1R - 488

**RE: "Corrective Action Plan - Preliminary Report"  
for the Vanguard Natural Resources, LLC's  
Abo SWD F-31 Site  
Unit Letter F, Section 31, T16S, R37E, NMPM, Lea County, New Mexico  
Remediation Plan (1R488) Boring Plan Approval**

Remediation Plan (1R488) Additional Delineation Required

**RE: "Corrective Action Plan Amendments"  
for the Vanguard Natural Resources, LLC's  
Abo SWD F-31 Site  
Unit Letter F, Section 31, T16S, R37E, NMPM, Lea County, New Mexico  
Remediation Plan (1R488) - Further Delineation Plan Approved**

**ABO F-31 AREA**  
Legals: UL/F SEC 31  
T16S R37E

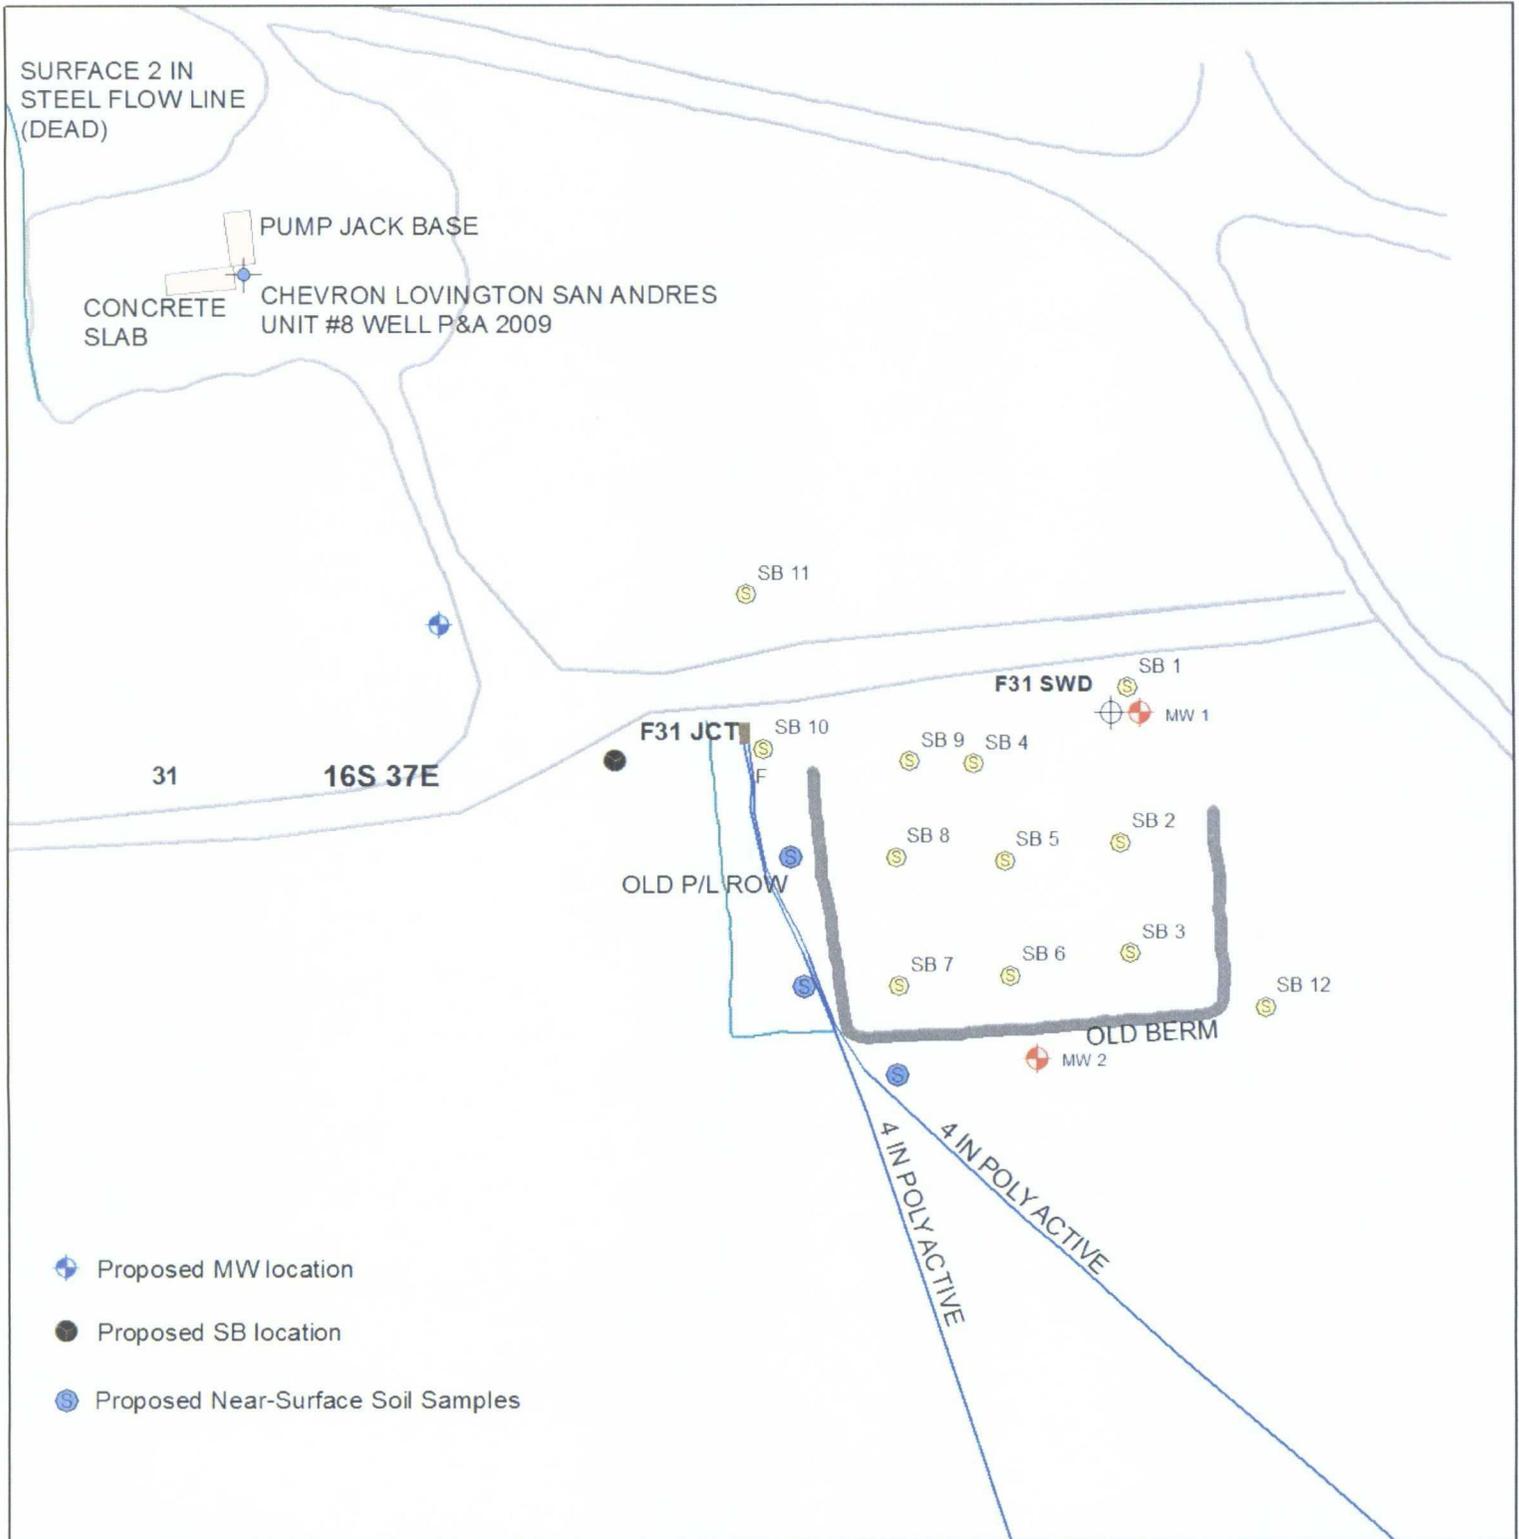
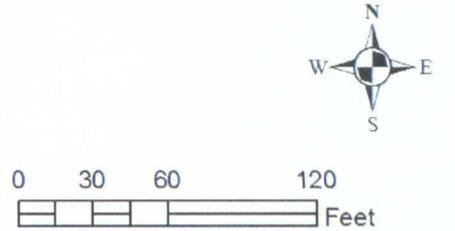
Attached is the proposed locations of soil bore/ sampling points and

monitor well locations at the Vanguard Abo F-31 site per the approved CAP, Additional Delineation Required dated August 25, 2010 for your review. If you have any questions please contact me.

The New Mexico Oil Conservation Division has reviewed the attached boring plan for the above-reference site. The Plan indicates that Vanguard Natural Resources, LLC's has met the requirements of 19.15.29 NMAC (Part 29; formerly, Rule 116) for a remediation plan. Therefore, the OCD hereby conditionally approves the Plan as proposed for above-referenced site in accordance with 19.15.29 NMAC:

Vanguard must follow the sampling and analytical protocol as outlined below.
